Westinghouse Electric Company  
Nuclear Power Plants  
P.O. Box 355  
Pittsburgh, Pennsylvania 15230-0355  
USA

Subject: AP1000 Response to Requests for Additional Information (SRP2.3.1)

Response to Requests for Additional Information on SRP Section 2.3.1

FIGURE 2.3.1-1 Percentage of Weather Stations with Extreme (Noncoincident) Wet Bulb Values Exceeding 86.5 °F

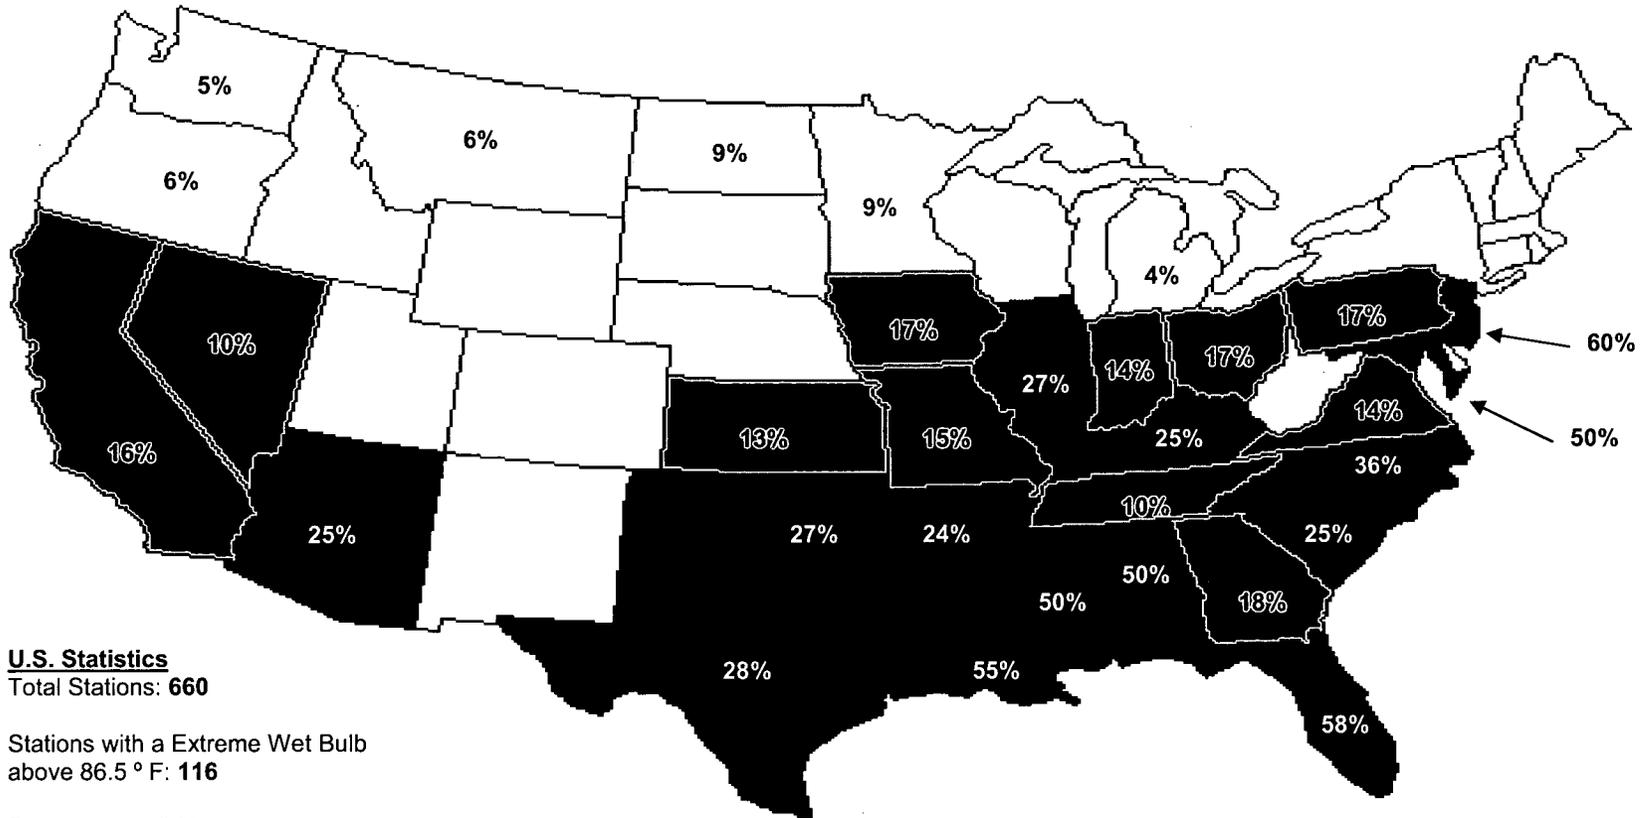
A map showing the percentage of weather stations in each state that exceed an extreme wet bulb temperature value of 86.5 °F is provided in Figure 2.3.1–1. This map shows that the states along the Gulf Coast and along the Southern and Mid-Atlantic Coasts (e.g., Texas through New Jersey) had the highest percentage of weather stations (ranging from 18% to 50%) with extreme wet bulb values exceeding 86.5 °F. These are also the same states where nearly half (e.g., 10 out of the 21) of the received or expected COL applications will be located. Consequently, please justify the selection of a maximum safety wet bulb (noncoincident) air temperature site parameter value of 85.5 °F as being representative of a reasonable number of sites that have been or may be considered for a COL application.

Westinghouse applied the URD requirements as a starting point for AP1000 design basis temperature selection. Using customer developed weather data, Westinghouse revised the value of some of the AP1000 design temperatures upwards to meet specific site requirements. All sites with submitted COLAs have site temperatures that lie within the existing AP1000 design parameters.

A DCD Impact Document is being generated to show that the maximum safety non-coincident wet bulb temperature for AP1000 is being revised from 85.5°F to 86.1°F. This document is scheduled to be submitted to the NRC by June 30, 2008.
